Plan Commission Agenda

March 12, 2024 - 7:00 PM

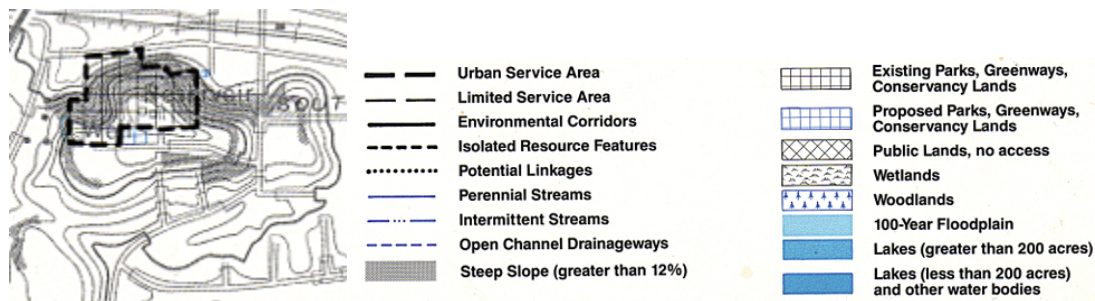
Comments:
